PART NUMBER 56200-02K

# Pump Flow Control Valve Kit

#### 56200-02K

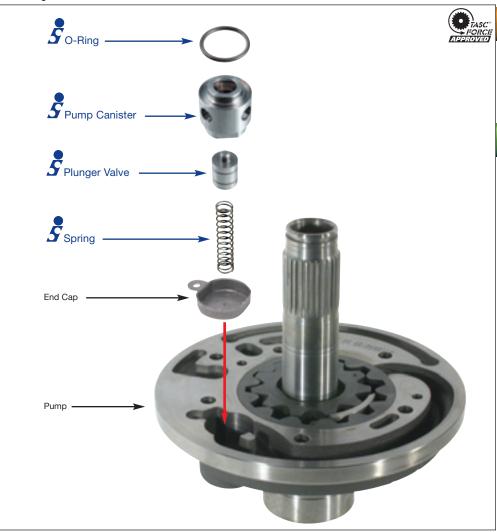
The pump flow control canister and plunger valve wear, allowing the plunger valve to stick open and/or leakage to occur. The canister o-ring relaxes and pressure bleeds past it.

This kit includes a harder canister with more support for the plunger valve, which prevents sticking, A case-hardened plunger valve with self-centering annular grooves, a replacement spring, and larger o-ring for improved sealing are also included.

- Harder canister material resists wear and has improved valve support to prevent sticking.
- Plunger valve is made from case-hardened steel and has annular grooves to prevent side loading.
- Larger o-ring eliminates pressure loss at the pump face.
